LINCOLN CITY/LANCASTER COUNTY PLANNING STAFF REPORT

for MAY 10, 2006 PLANNING COMMISSION MEETING

PROJECT #: Charleston Heights Special Permit No.06030

PROPOSAL: Community Unit Plan for 206 single family lots and 144 attached single-family lots for a total of 350 dwelling units.

**SITE PLAN
CUP - SPECIAL PERMIT #
CHARLESTON HEIGHTS**

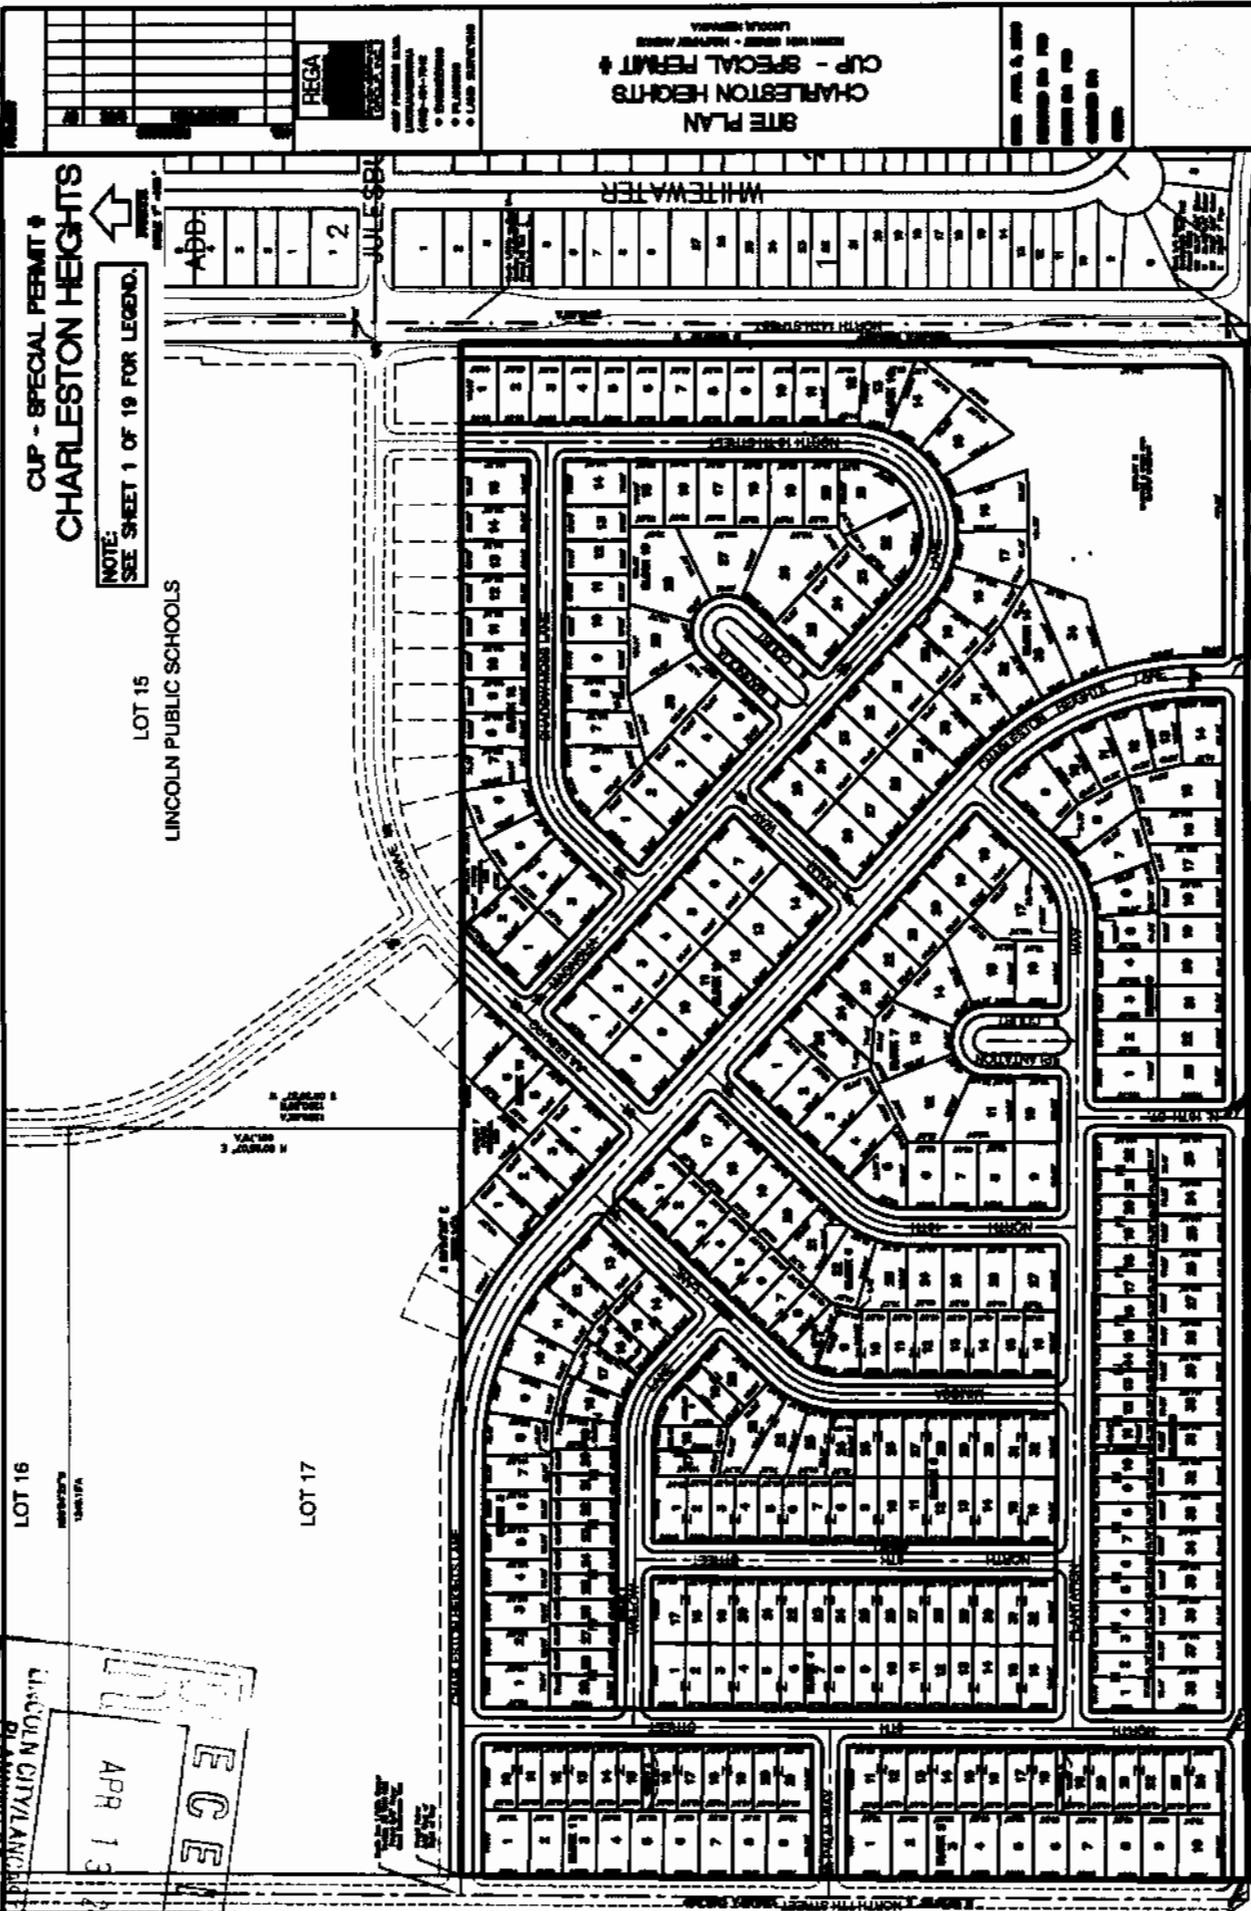
It appears that a pedestrian connection or a street connection would be possible between Charleston Heights Lane and Magnolia lane near the proposed detention cell. The requested waiver of pedestrian easement for block length does not appear to be justified.

Magnolia Court and Plantation Court need to be shown as 27' wide paving.

- 5. Before a final plat is approved:
 - 5.1 The permittee shall complete the following instructions and submit the documents and plans to the Planning Department office for review and approval.
 - 5.1.1 A revised site plan including **5** copies showing the following revisions:
 - 5.1.1.1 Make revisions to the satisfaction of the Public Works & Utilities Department comments of April 26, 2006.
 - 5.1.1.2 Make revisions to the satisfaction of Watershed Managements comments of April 26, 2006.
 - 5.1.1.3 The extension of Plantation Way through to Magnolia Lane or the creation of another north-south street connecting Charleston Heights Lane and Magnolia Lane.

- 5.1.1.5 Reduction in the right of way widths to 60 feet on both Julesburg Drive and Charleston Heights Lane.
- 5.1.1.6 Show utility easements as requested by LES report of April 21, 2006.

- 5.1.1.9 Remove the City Council approval block from the cover sheet. This special permit is final action at Planning Commission unless appealed.
- 5.1.1.10 Change Magnolia Court and Plantation Court to private streets or show 27' wide paving if they are to remain public streets.
